ADDENDUM NO. 1

Bid #1506
ORANGE EDUCATION CENTER PORTABLES PHASE II
at
ORANGE EDUCATION CENTER

Project ID #3762, DSA #04-125366

ADDENDUM 1

A5.16-2

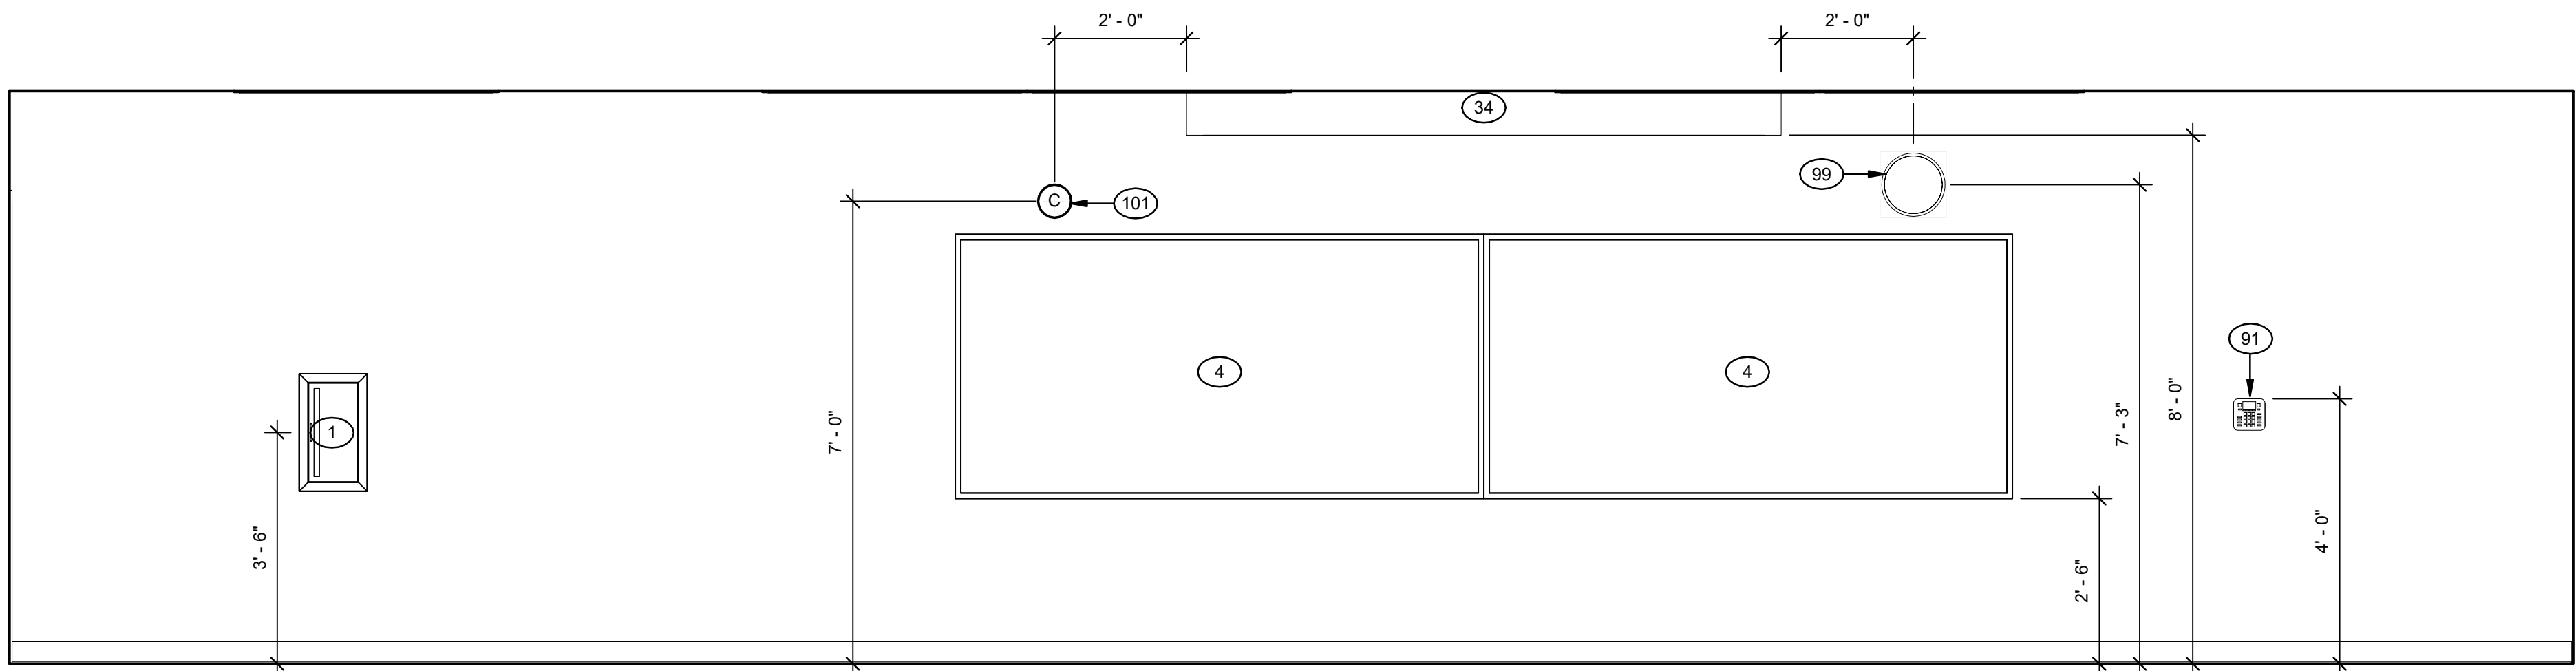
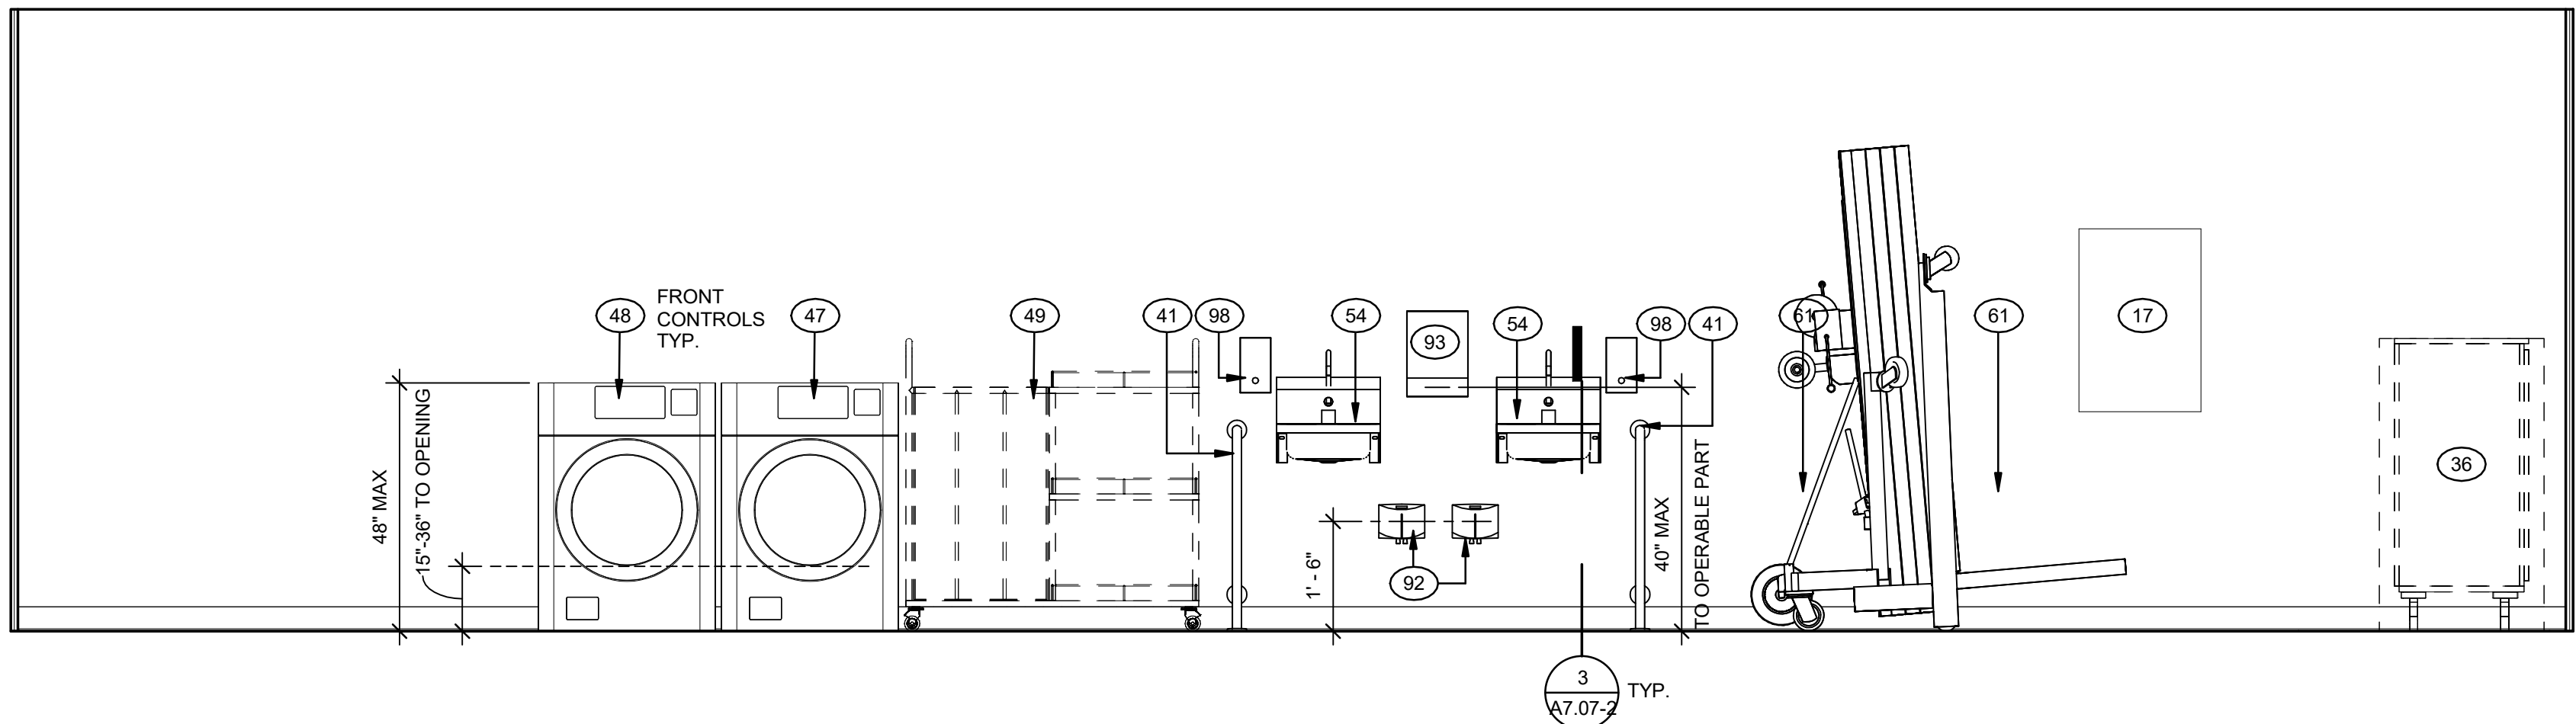
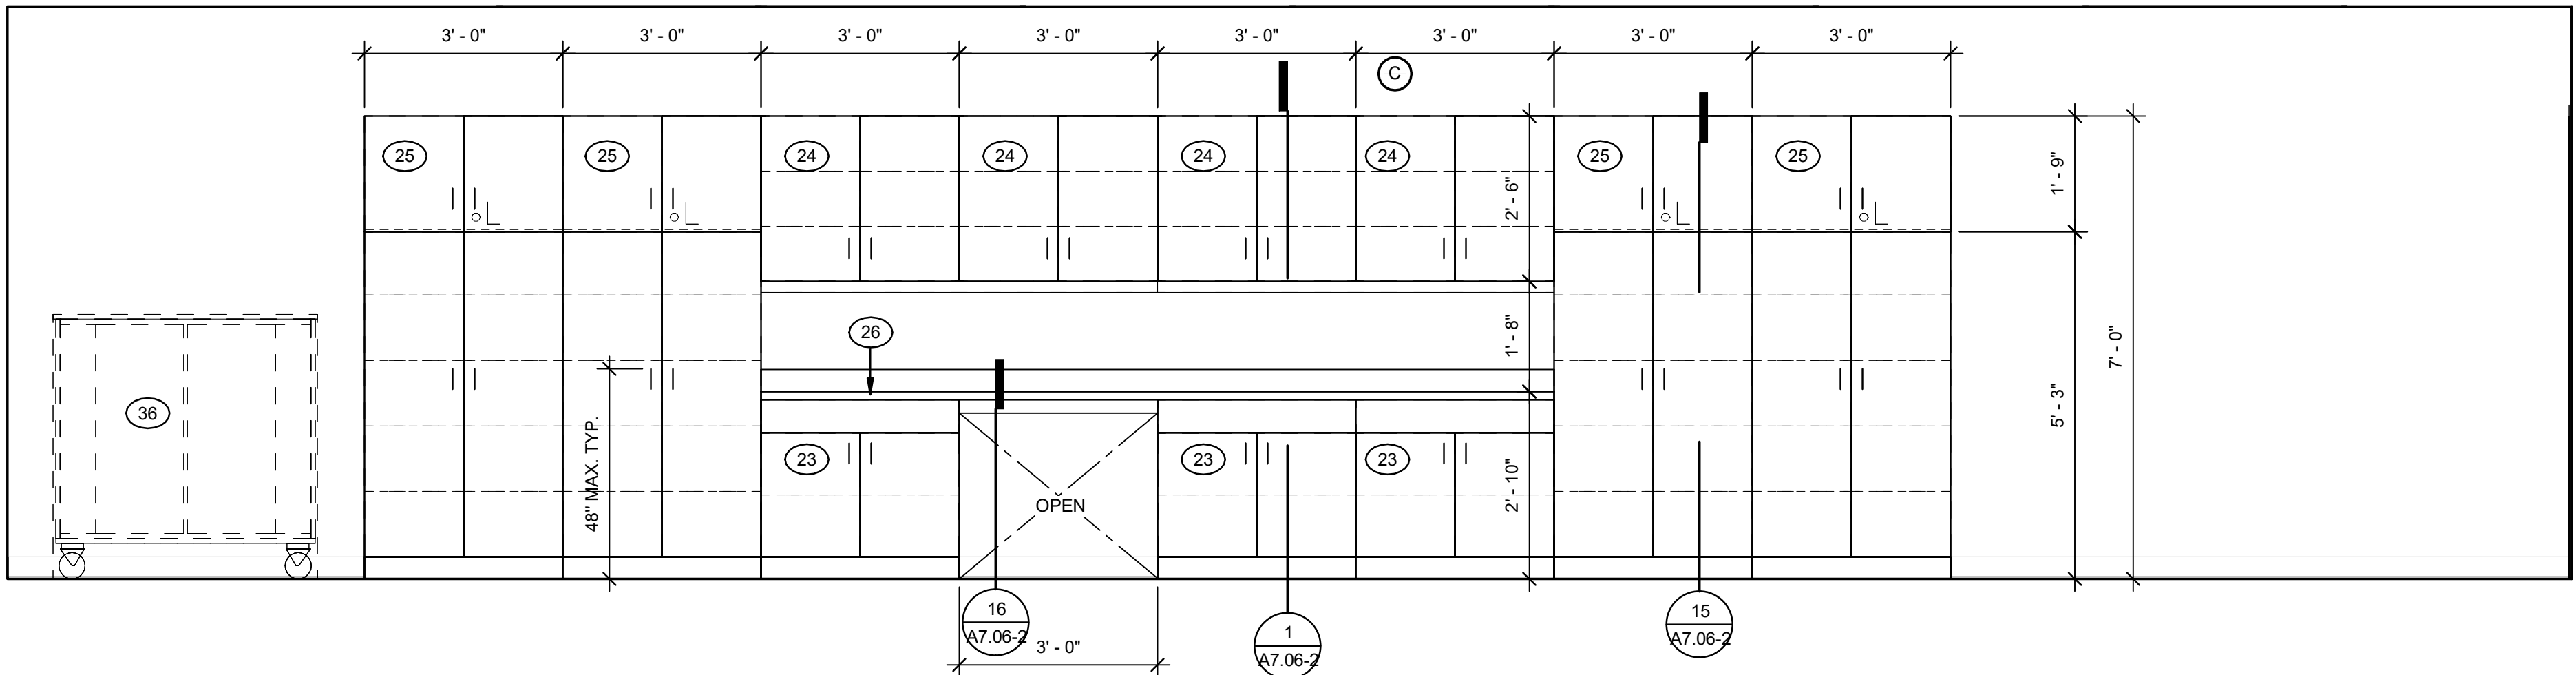
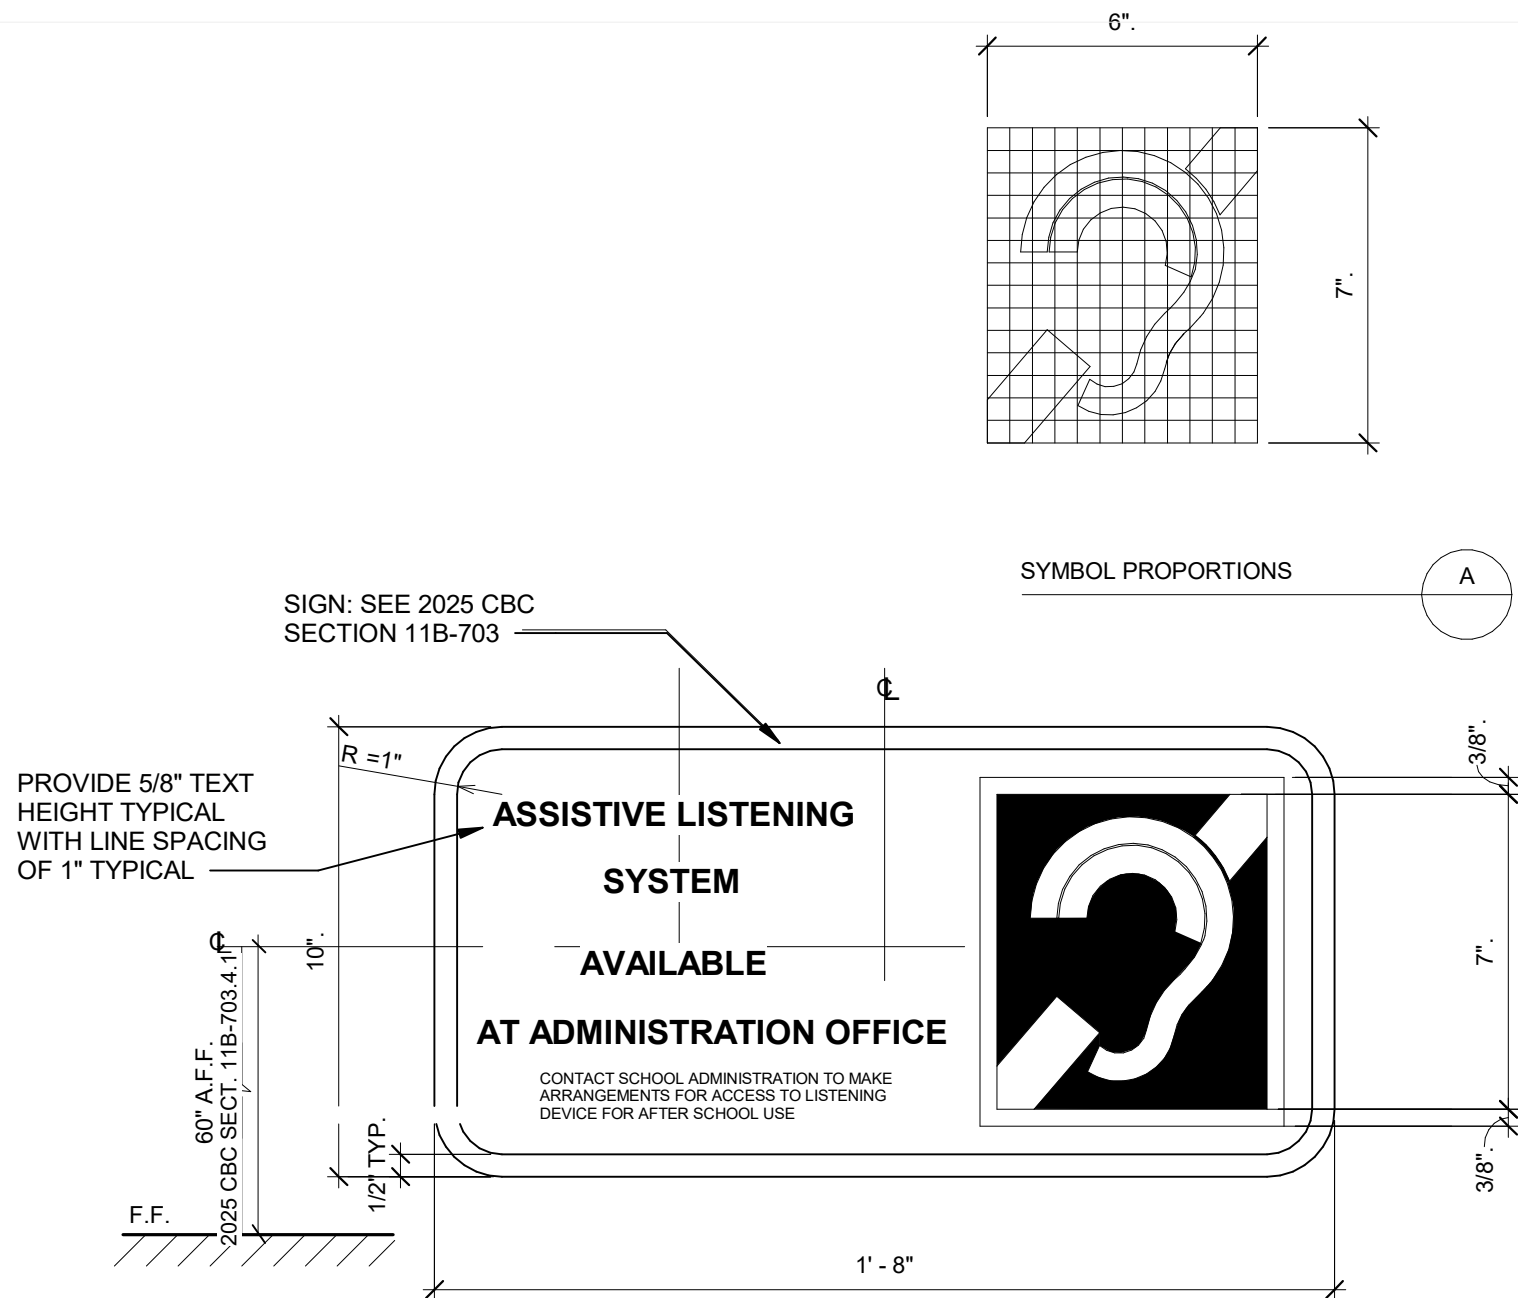
- D. Added in Interior Elevation General Note that all cabinet doors and drawers must be lockable.
7. **A5.16-2:**
 - A. All casework (cabinets and drawers) in Portable 208 shall have locks.

- B. Wall mounted medical equipment added at hospital bed headboard to clarify function and adjacencies.
 - C. Added in Interior Elevation General Note that all cabinet doors and drawers must be lockable.
